CONTRACT NO. 1797

OHIO RIVER TUNNEL

ADDENDUM No. 6

All bidders bidding Contract No. 1797 shall read and take note of this Addendum No. 6. The Contract Documents for Contract No. 1797 – Ohio River Tunnel are hereby revised and/or clarified as stated below.

• Revised A48-ST-300 (Sheet 361 of 770) (1 page)

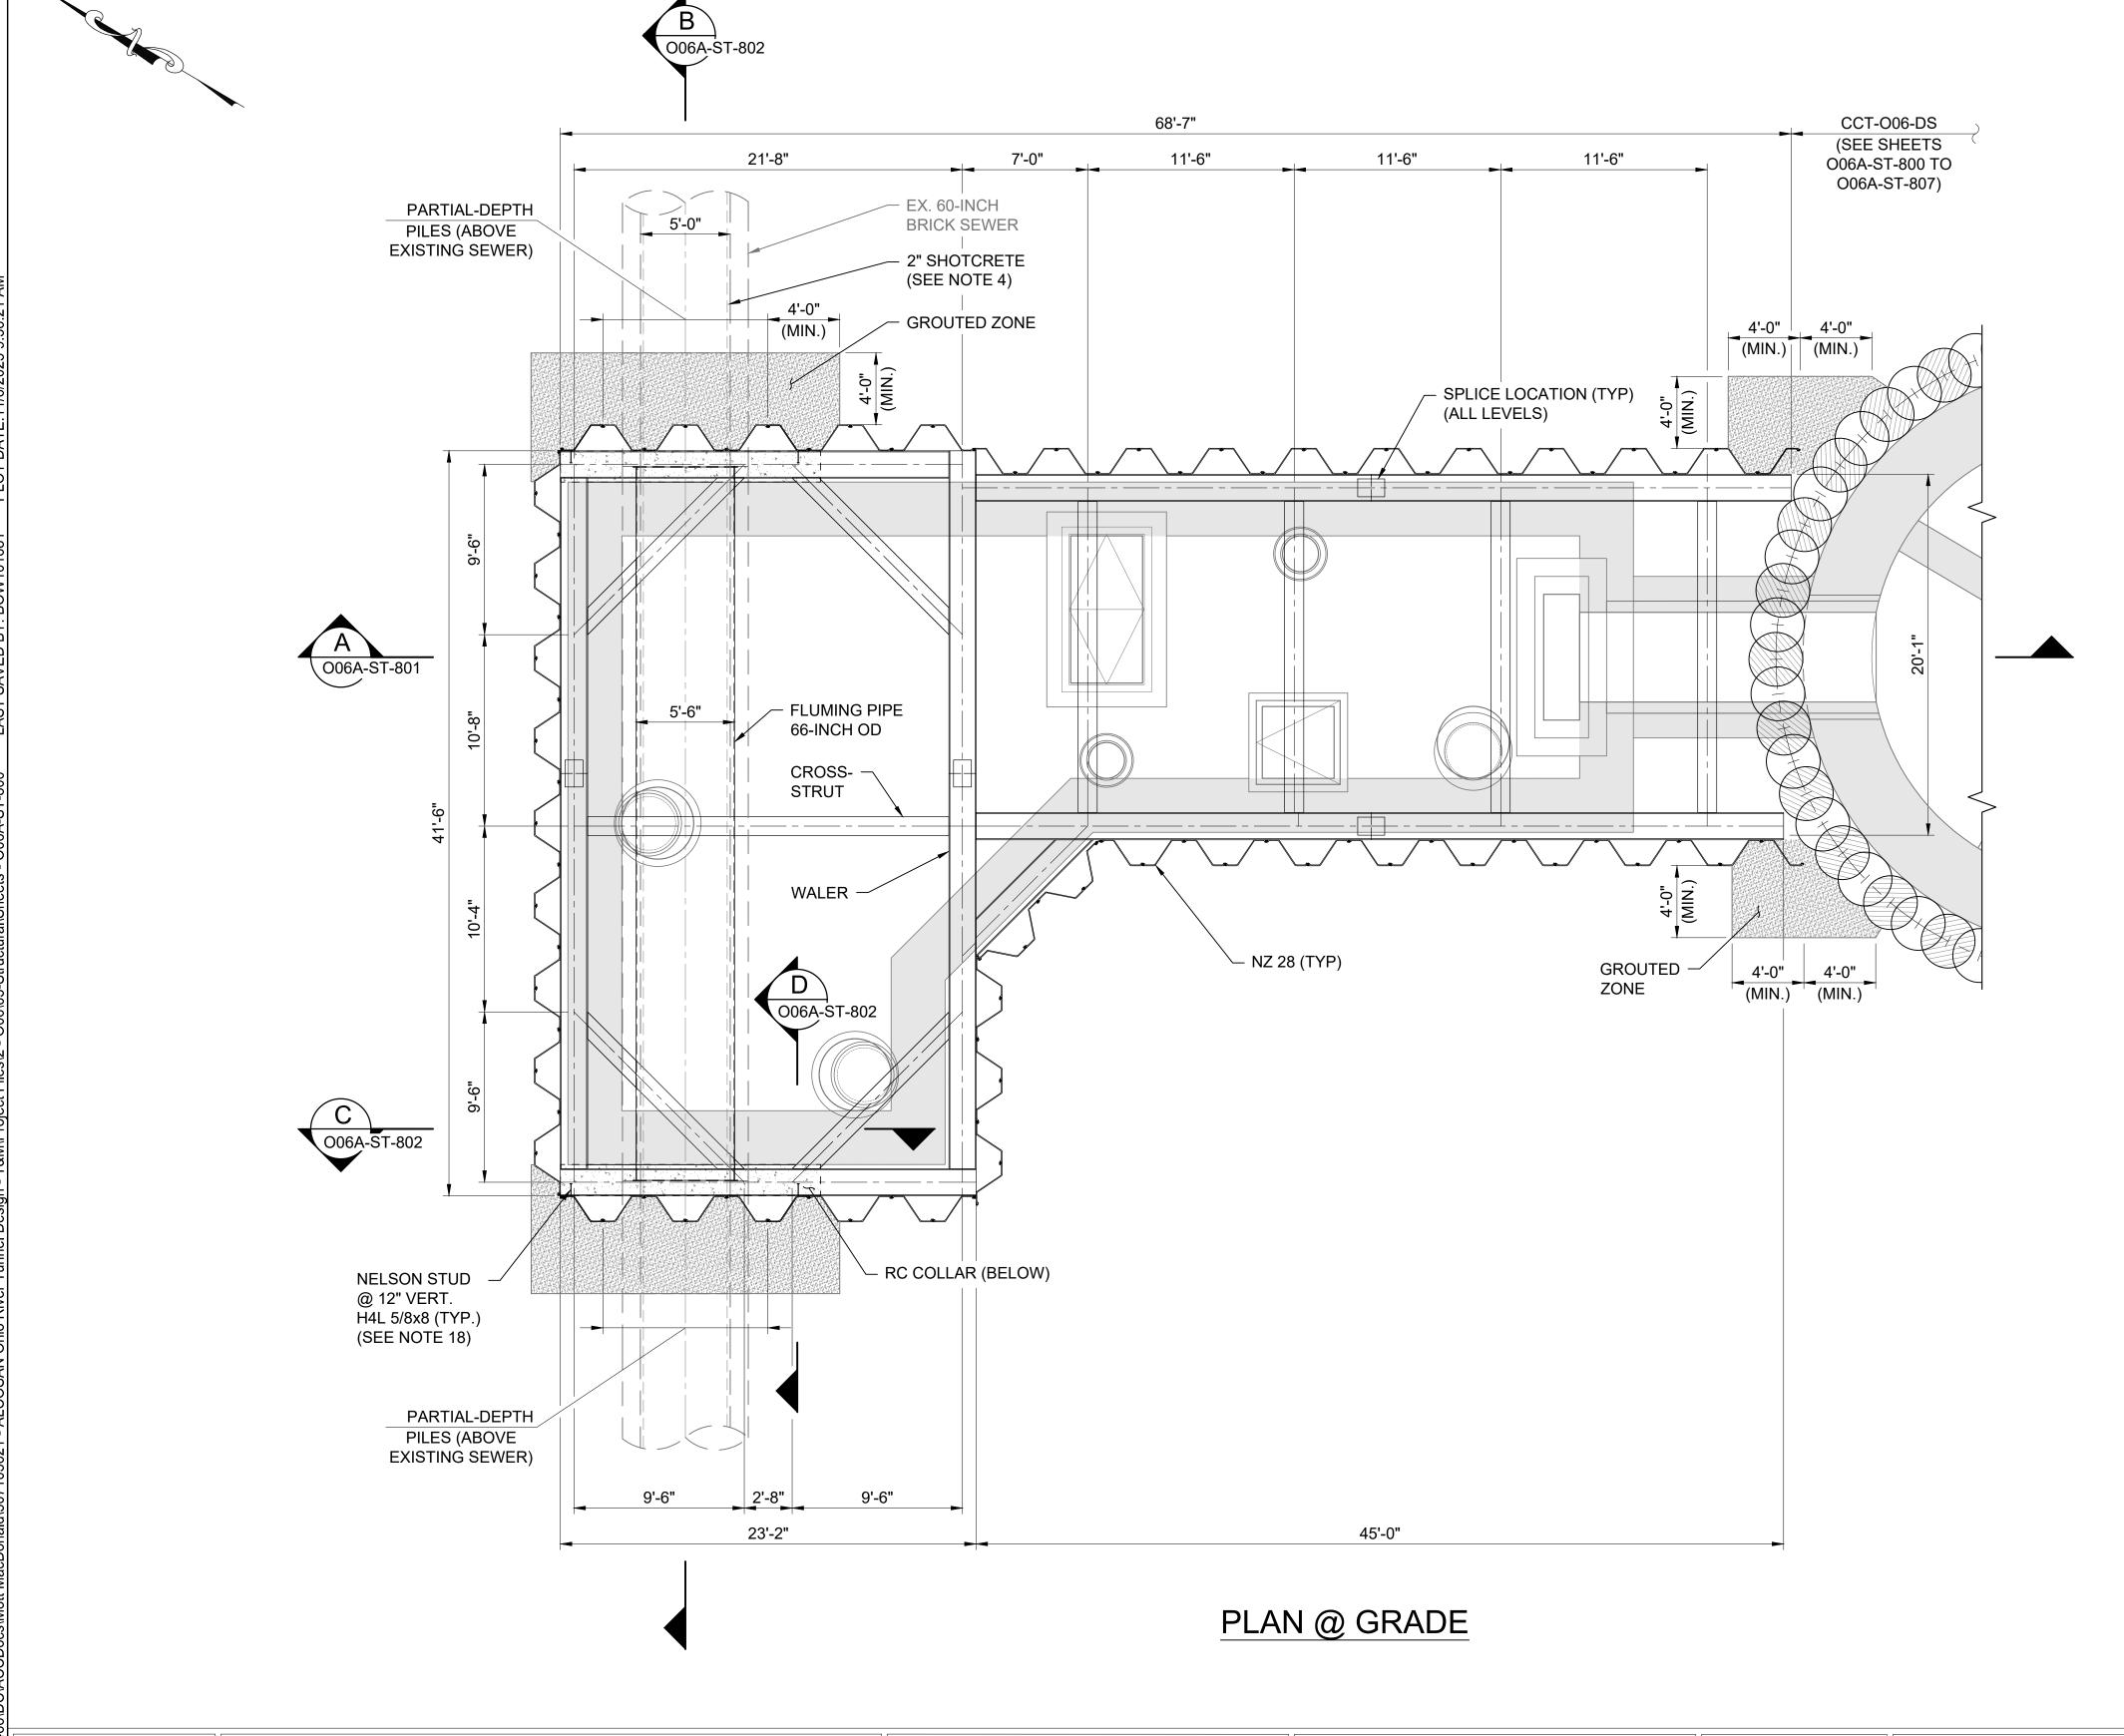
- Q38 At site A48 for the bypass pumping, it states it can be pumped to MH008F002 and this manhole can be found on A48-CI-300. It is not shown on this drawing. Please provide the location for this manhole.

- A38 Note 4 on Contract Drawing A48-ST-300 has been updated. See Section B, Item 8 CHANGES TO CONTRACT DOCUMENTS for revisions.
- Q39 Specification 31 62 16 notes that it covers Control Buildings, Outfalls, and other structures. Subsection 3.2.A states: "Install steel H-piles by pre-drilling to their proposed tip elevations. Impact and vibratory driving for steel H-pile installation is prohibited." The Contract drawings clearly show the pre-drilled holes for the Outfall at A58. However, no drilled holes are shown at either Control Building at A58 or O27. Moreover, Inspection Notes on Tables 1705.7 at both locations discuss recording hammer type and blows per foot. Are the H-Piles at the Control Buildings to be installed by impact driving?

- a) DELETE A48-ST-300 (Sheet 361 of 770) and ADD Revised A48-ST-300 (Sheet 361 of 770), which is Attachment A to this Addendum.
- b) DELETE O06A-ST-800 (Sheet 623 of 770) and ADD revised O06A-ST-800 (Sheet 623 of 770), which is Attachment B to this Addendum.
